PRODUCT CHANGE NOTIFICATION COVERSHEET

CTS Part Number:	TF32 Crystal Platform	Product Description:	32.768kHz Crystal Product
------------------	-----------------------	----------------------	---------------------------

Reason for PCN: Correct typo for load capacitance code in Ordering Information part number

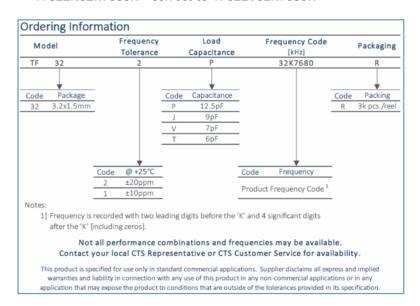
Description for Change: The load code "N" was used for 7pF value. This was a typographical error and

should be code "V".

Load corrected part numbers in PRMS. Complete.
TF321N32K7680R - corrected to TF321V32K7680R
TF322N32K7680R - correct to TF322V32K7680R
